RC2

We thank the reviewer for his/her positive appreciation of our manuscript. Below, we detailed our answers to his/her specific comments and describe how they have been accounted for.

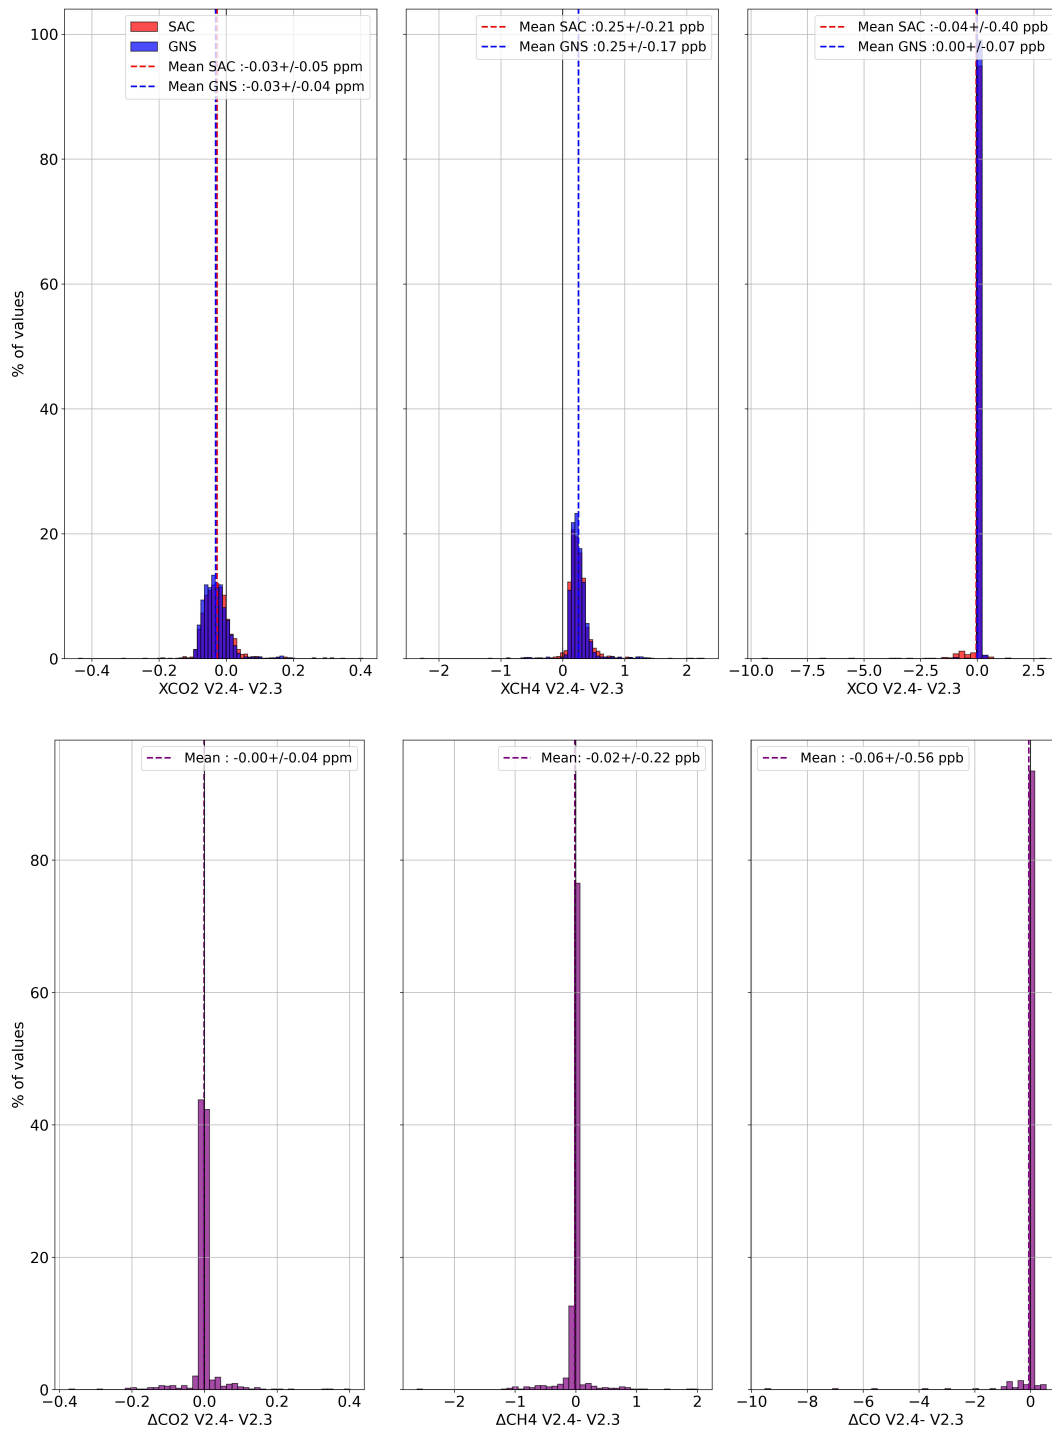
25. L140 – PROFFAST 2.4.1 is the latest version and PROFFASTpylot is at v1.3. Why are older PROFFAST/PROFFASTpylot versions being used in this analysis? I suggest the authors update the PROFFAST/PROFFASTpylot versions for this analysis, if possible. (Or provide an estimate of how much the results would vary upon using the latest PROFFAST and PROFFASTpylot versions.)

Using the two figures above, the following comment has been added to the main text:

Between versions 2.3 and 2.4 of PROFFAST, the XCO₂ estimates differ, on average, by -0.03 ppm with some dispersion around this mean value: 90% of the XCO₂ differences are between -0.08 and 0.03 ppm. There are a few outliers (up to 0.4 ppm) but we have not been able to identify how these outliers differ from the typical case. The XCO₂ differences (between the two versions) of PROFFAST are correlated between the two ICOS stations so that the dispersion in term of ΔXCO₂ is lower than the dispersion on XCO₂. Indeed, 90% of the ΔXCO₂ changes (between two versions of PROFFAST) are between -0.03 and 0.03 ppm. These differences are relatively small in comparison to the other sources of errors. They are therefore neglected in the following.
